Service Bulletin No: 57-012

Modification No: EC-11-0355

**WINGS - OUTER WING
REPLACEMENT OF THE LEFT AND RIGHT AILERON OUTBOARD BEARING-BRACKETS****1. Planning Information****A. Effectivity**

PC-9(M) aircraft MSN 605, MSN 617 thru MSN 670.

Removal / Installation of the Shim and Bracket
Figure 1

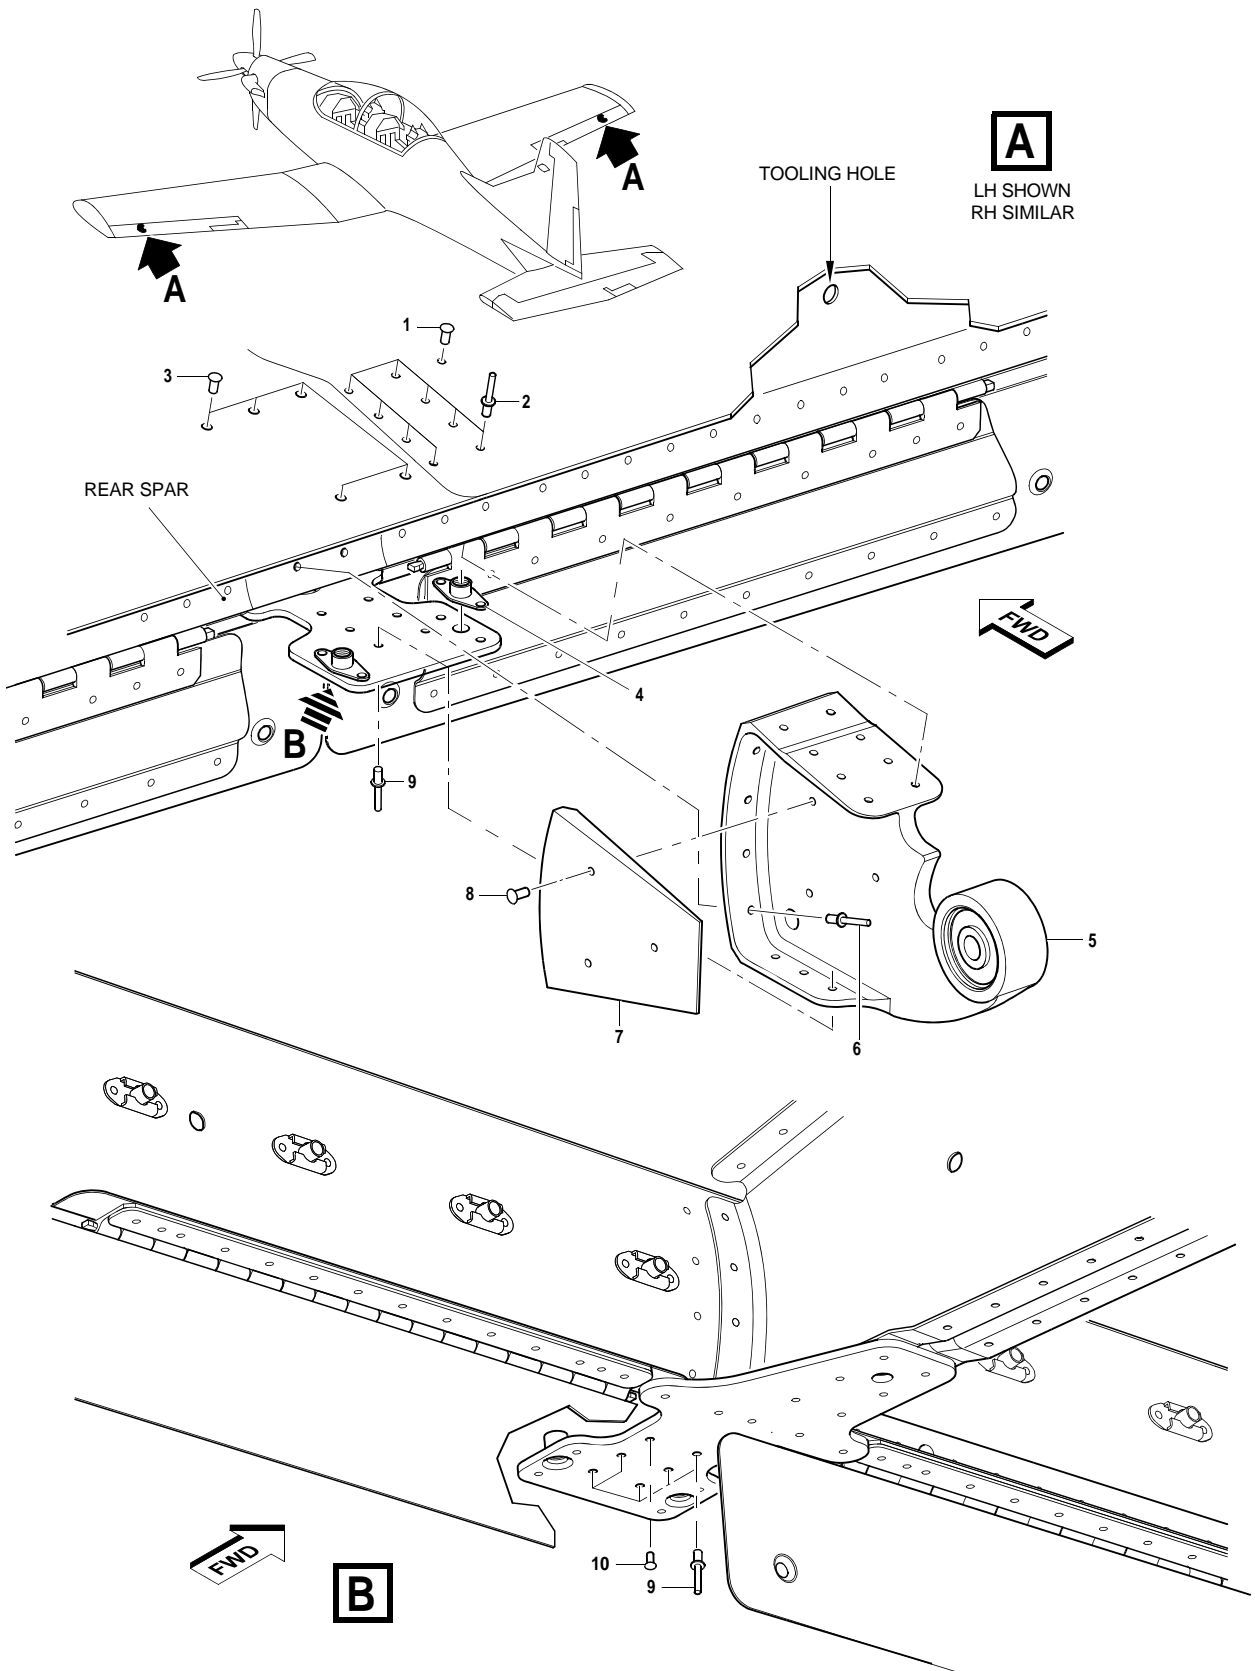
- (1) If installed, make a note of the position of the shim (7) on the applicable bracket (5).
- (2) If installed, use the applicable sized drill and remove the three rivets (8) that attach the shim (7) to the applicable bracket (5).
- (3) Remove and keep the shim (7).
- (4) Remove the five rivets (3) from the top skin, outboard of the bracket (5).

- (5) Remove the four outboard rivets (6) that attach the flange of the bracket (5) to the wing rear spar.

- (1) Measure and record the height of the tail of the inboard forward rivet (10) that attaches the flange of the bracket (5) to the lower skin.
- (2) Remove the six rivets (9 and 10) that attach the flange of the bracket (5) to the lower skin.
- (3) Remove the eight rivets (2) that attach the flange of the bracket (5) to the upper skin.
- (4) Remove the rivet (1) from the upper skin.

- (6) Remove the remaining four inboard rivets (6) that attach the flange of the bracket (5) to the wing rear spar.
- (7) Remove the bracket (5).
- (8) Remove, and keep, the spherical bearing from the bracket (5).

- (1) Put the shim (7) in the same position on the new bracket (5) (P/N 557.22.09.547, LH or P/N 557.22.09.548, RH) as noted in Step 3.B.(1).
- (2) Use a 2.4 mm diameter drill and drill the three holes that attach the shim (7) to the new bracket (5) (P/N 557.22.09.547, LH or P/N 557.22.09.548, RH). Do this through the holes in the shim (7).
- (3) Countersink the inboard holes in the new bracket (5) (P/N 557.22.09.547, LH or P/N 557.22.09.548, RH).
- (4) Remove the shim (7).

- (1) Deburr all the drilled holes in:
 - The new bracket (Fig. 1, Item 5) (P/N 557.22.09.547, LH or P/N 557.22.09.548, RH)
 - The upper skin
 - The lower skin
 - The wing rear spar.

- (12) Install the rivet (Fig. 1, Item 10) (P/N NAS1097AD4) in the forward inboard hole in the location shown.
- (13) Make sure the tail of the rivet (Fig. 1, Item 10) (P/N NAS1097AD4) is the same dimension as recorded at Step 3.D.(1). The minimum height is 0.5 mm. If necessary, remove material from the tail.
- (14) Install the remaining rivets (Fig. 1, Item 9) (P/N CR3224-4) in the other five positions.

- (20) Remove the dirt and grease from the shim (Fig. 1, Item 7) with the absorbent paper (Material No. P02-031) made moist with the solvent (Material No. P01-010).
- (21) Apply a layer of the sealant (Material No, P08-020) to the shim (Fig. 1, Item 7).
- (22) Put the shim (Fig. 1, Item 7) in position.
- (23) Install the three rivets (Fig. 1, Item 8) (P/N NAS1097AD3) with a countersunk on both sides of the joint.

- (26) Install the lower inboard anchor-nut (Fig. 1, Item 4) with the rivets (P/N NAS1097AD3).
- (27) Make the tooling hole in wing rear spar (Ref Fig. 1) larger with a 7.0 mm diameter drill.
- (28) Deburr the hole.

Installation of the Placing Device
Figure 2

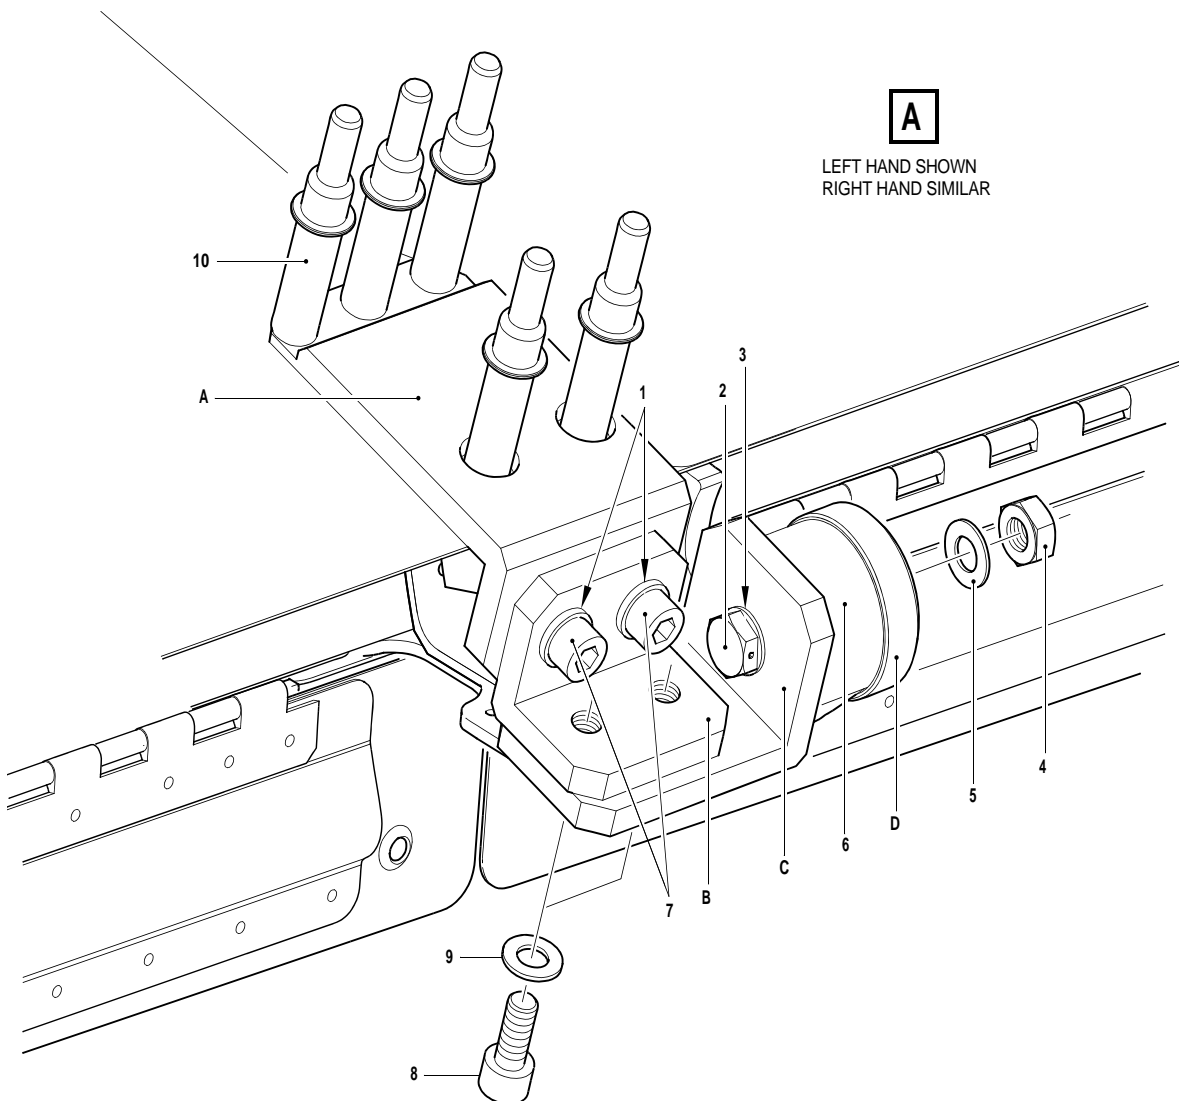
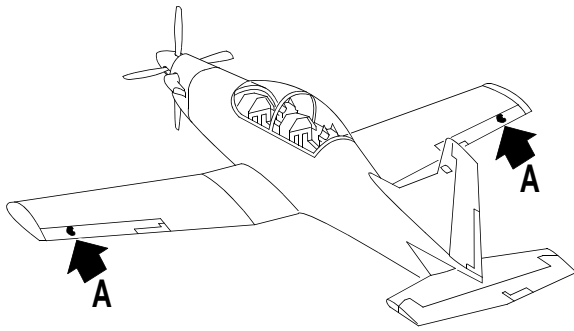
- (1) Make sure there are no pencil marks on all parts of the placing device. If necessary, remove them with the absorbent paper (Material No. P02-031) made moist with the solvent (Material No. P01-010).
- (2) Put part A of the placing device in position on the top skin.
- (3) Hold in position with gripper pins, or equivalent, (10) through the five rivet holes in the top skin.

- (4) Put part C in position against the bearing of the bracket (6). Make sure the mating face of the bracket is smooth. If necessary, remove the paint.
- (5) Install the bolt (2), the washer (3), part D of the placing device, the washer (5) and the nut (4). Do not tighten the nut (4).
- (6) Put part B of the placing device in position against part A and part C of the placing device.
- (7) Install the two screws (7) and the washers (1).
- (8) Install the two screws (8) and the washers (9).
- (9) Make sure the gripper pins, or equivalent, (10), the screws (7 and 8) are tight.
- (10) Make sure that:
 - The bolt (2) and the spherical bearing can move freely
 - Part C of the placing device is in complete contact with the bracket (6).

- (11) Tighten the nut (4).
- (12) Draw lines around part A of the placing device to show its position on the wing top skin.
- (13) Draw lines around part B of the placing device to show its position against part A.
- (14) Draw lines around part B of the placing device to show its position against part C.

- (6) Put the washer (Fig. 2, Item 3) on the bolt (Fig. 2, Item 2).
- (7) Put the bolt (Fig. 2, Item 2) through part C (Fig. 2) of the placing device and the new bracket (Fig. 2, Item 6) (P/N 557.22.09.547, LH or P/N 557.22.09.548, RH).

- (8) Put the spherical bearing in the new bracket (Fig. 2, Item 6) (P/N 557.22.09.547, LH or P/N 557.22.09.548, RH) and on the bolt (Fig. 2, Item 2).
- (9) Install part D (Fig. 2) of the placing device, the washer (Fig. 2, Item 5) and the nut (Fig. 2, Item 4).

- (10) Keep the new bracket (Fig. 2, Item 6) (P/N 557.22.09.547, LH or P/N 557.22.09.548, RH) in position with gripper pins or equivalent (Fig. 2, Item 10).

Replacement of the Bracket Assembly
Figure 3

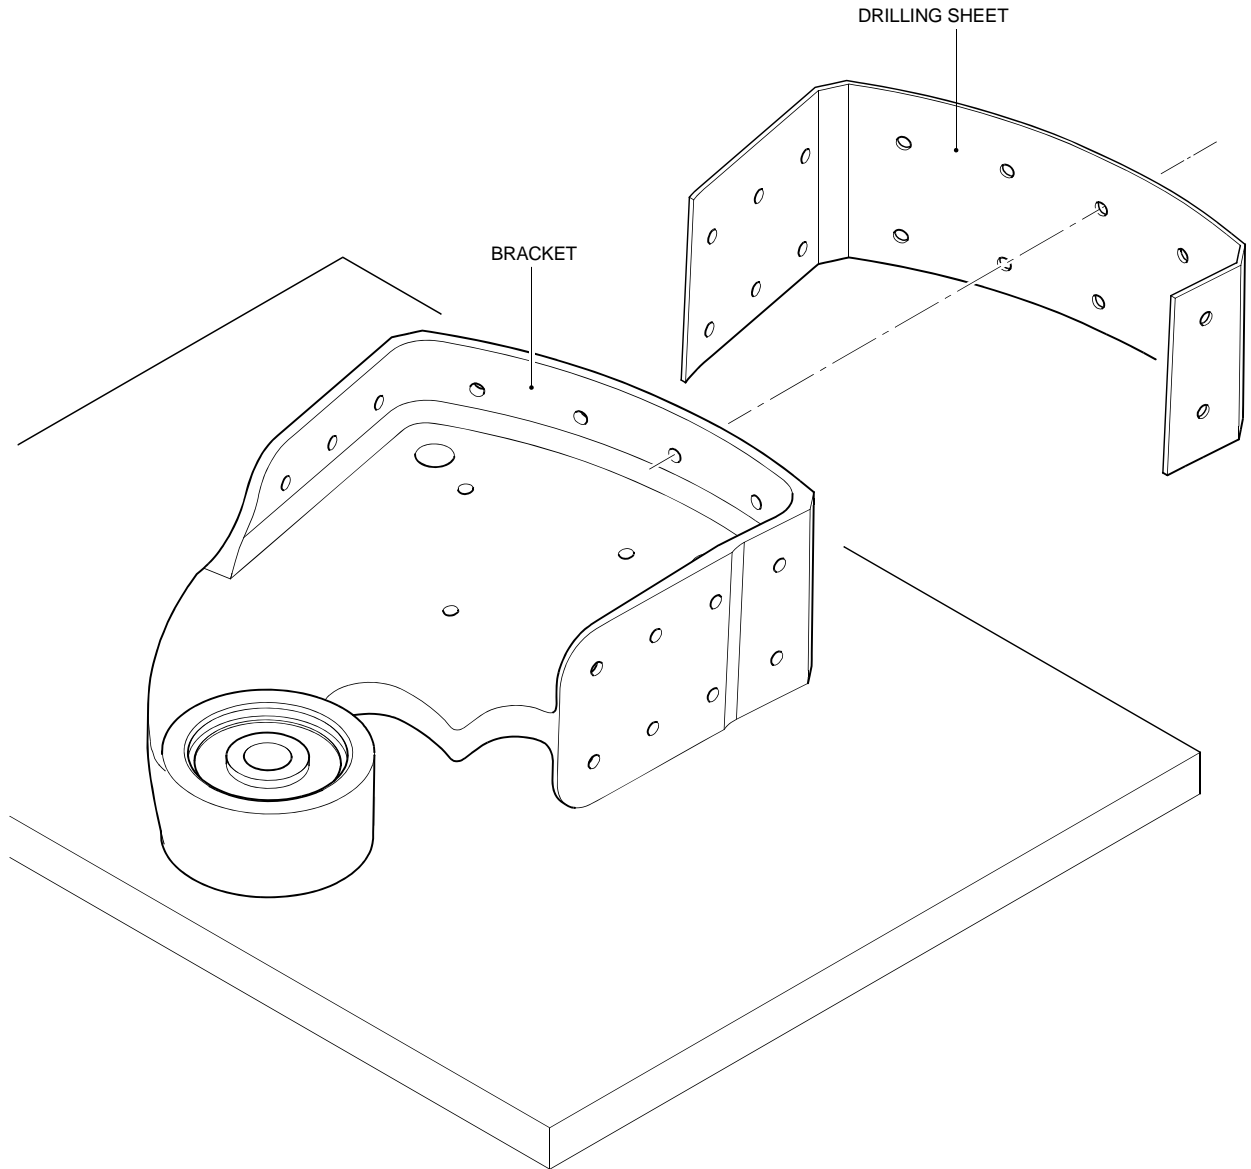
- (1) Put the drilling sheet (P/N 513.57.09.153, LH or P/N 513.57.09.154, RH) against the old bracket.
- (2) Use a 3.2 mm diameter drill and drill the six holes in the drilling sheet (P/N 513.57.09.153, LH or P/N 513.57.09.154, RH). Do this through the holes in the lower flange of the old bracket.

- (4) Make sure the drilling sheet (P/N 513.57.09.153, LH or P/N 513.57.09.154, RH) is firmly against the wing rear-spar flange of the old bracket.
- (5) Use a 3.2 mm diameter drill and drill the eight holes in the drilling sheet (P/N 513.57.09.153, LH or P/N 513.57.09.154, RH). Do this through the holes in the wing rear-spar flange of the old bracket.

- (6) Make sure the drilling sheet (P/N 513.57.09.153, LH or P/N 513.57.09.154, RH) is firmly against the upper flange of the old bracket.
- (7) Use a 3.2 mm diameter drill and drill two holes in the drilling sheet (P/N 513.57.09.153, LH or P/N 513.57.09.154, RH). Do this through the first two holes (nearest to the wing rear-spar flange) in the upper flange of the old bracket.

- (1) Put the drilling sheet (P/N 513.57.09.153, LH or P/N 513.57.09.154, RH) (that you prepared in Step 3.E) in position on the new bracket.
- (2) Install gripper pins, or equivalent, in the six holes on the lower flange and in the two holes on the upper flange.
- (3) Use a 3.2 mm diameter drill and drill the eight holes that attach the flange of the new bracket to the rear wing spar. Do this through the holes in the drilling sheet.
- (4) Remove the drilling sheet from the new bracket.
